ACCESSION NBR: 8303280087 DOC. DATE: 83/03/21 NOTARIZED: NO
 FACIL: 50-389 St. Lucie Plant, Unit 2, Florida Power & Light Co.
 AUTH. NAME: UHRIG, R.E. AUTHOR AFFILIATION: Florida Power & Light Co.
 RECIP. NAME: EISENHUT, D.G. RECIPIENT AFFILIATION: Division of Licensing

SUBJECT: Forwards Suppl A to "Independent Verification of Design & Const for St Lucie Unit 2 Nuclear Generating Station, Resolution of Discrepancies & Corrective Action Plans."

Re: ST. LUCIE UNIT NO. 2
DOCKET NO. 50-389
ENGINEERING VERIFICATION PROGRAM

SUPPLEMENT A
RESOLUTION OF DISCREPANCIES
AND
CORRECTIVE ACTION PLANS

FIGURE 1
ENGINEERING VERIFICATION PROGRAM
STEP PROCEDURE FOR RESOLUTION
OF DISCREPANCIES

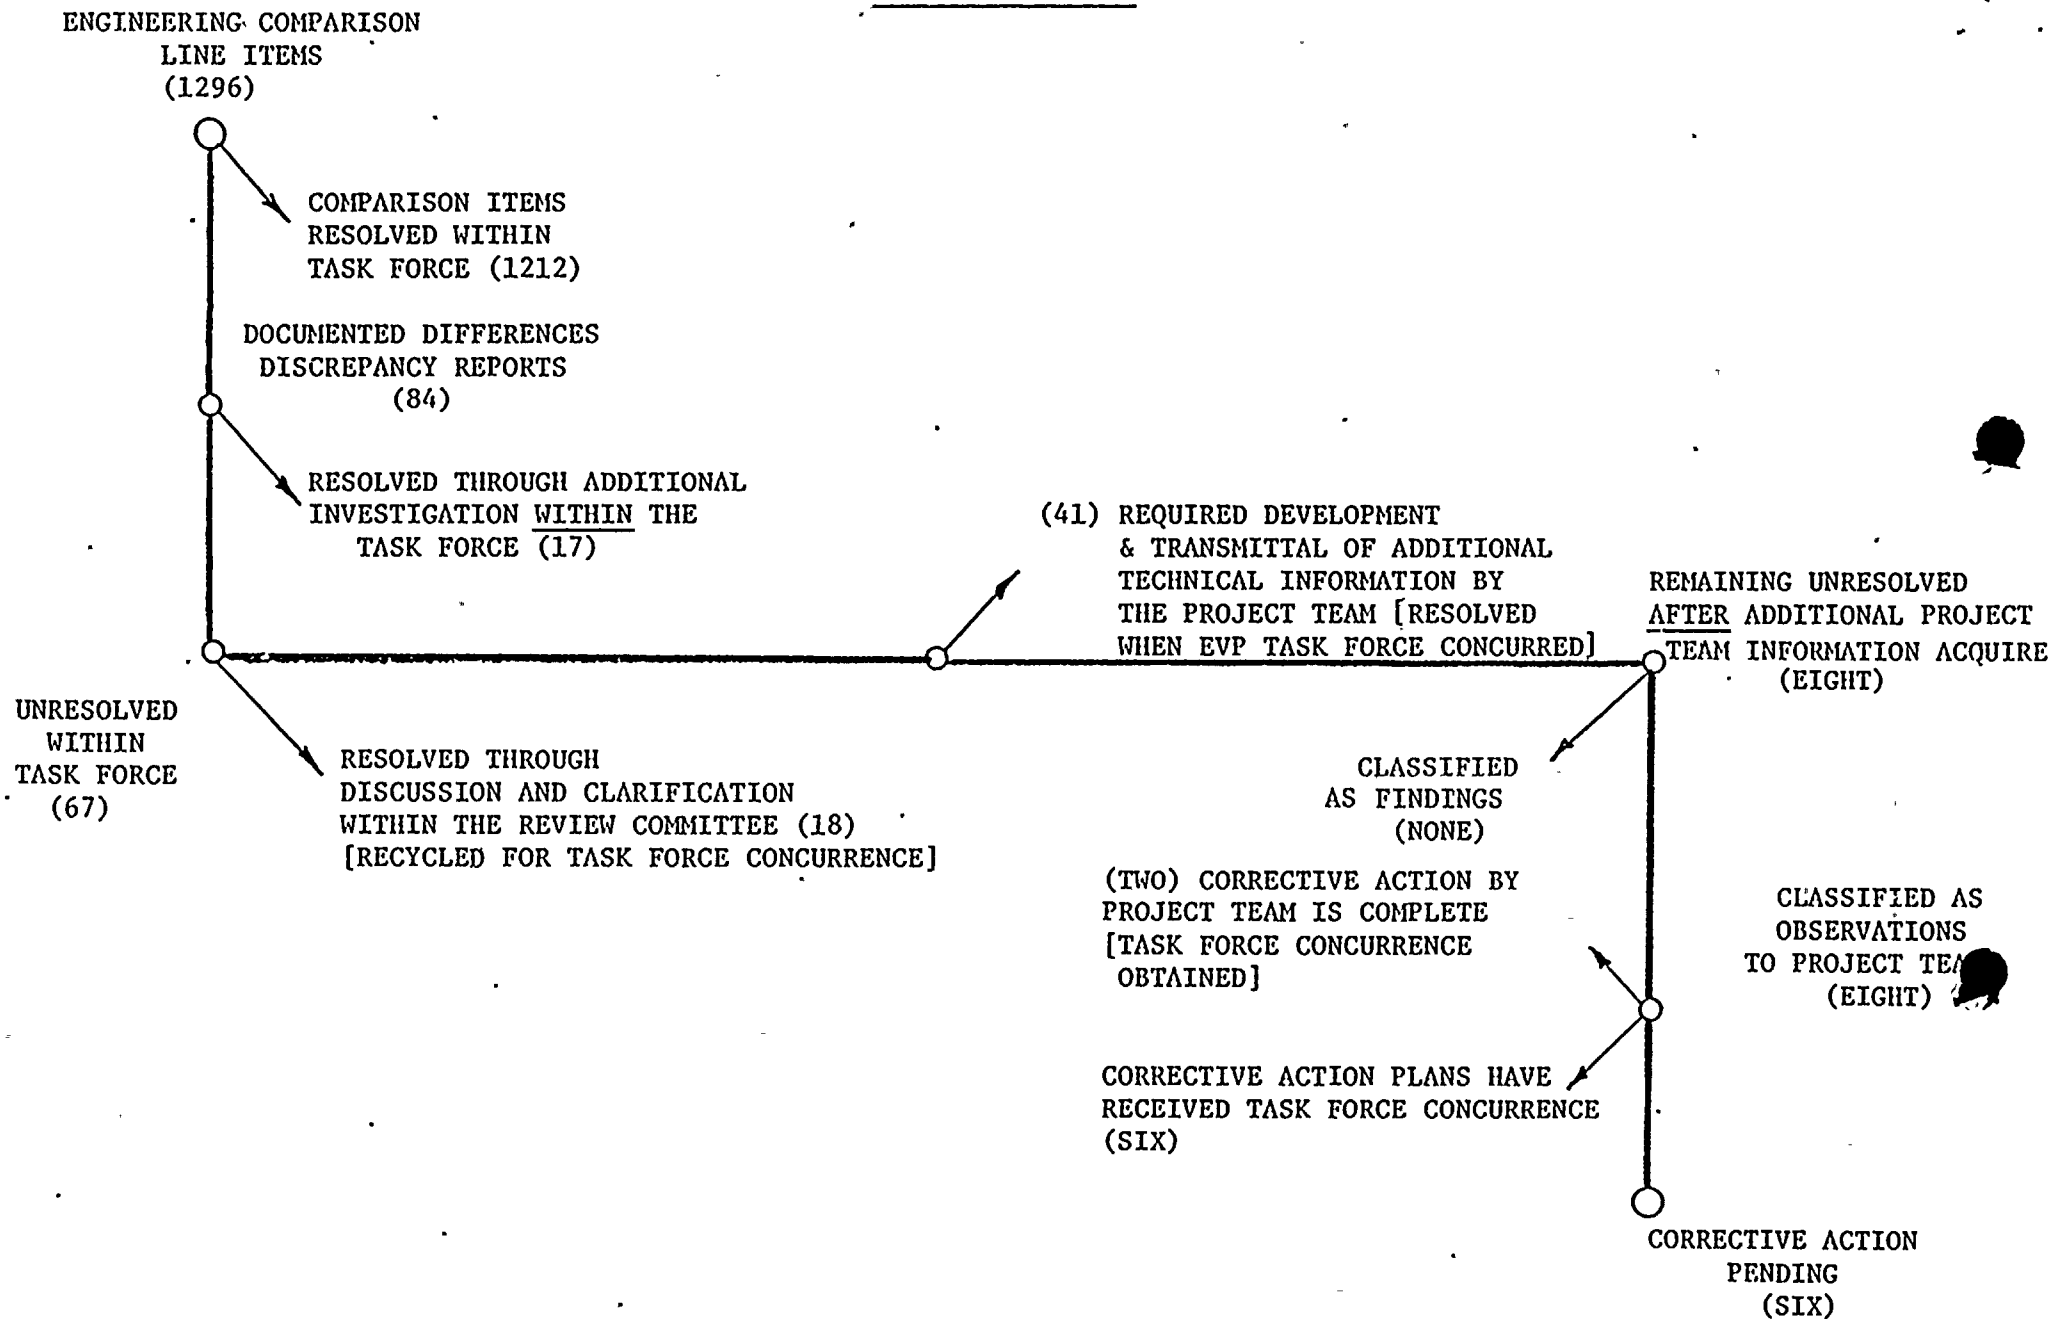
Figure 1 is a step-by-step procedure demonstrating, in flow chart format, the process used for resolution of differences between the independent and existing design along with discrepancies noted in installation and testing of verification items. The six-step process shows how the EVP Task Force, assisted by the Review Committee and the St. Lucie Unit 2 Project Team, carried the program from design comparison through approval of corrective actions now underway.
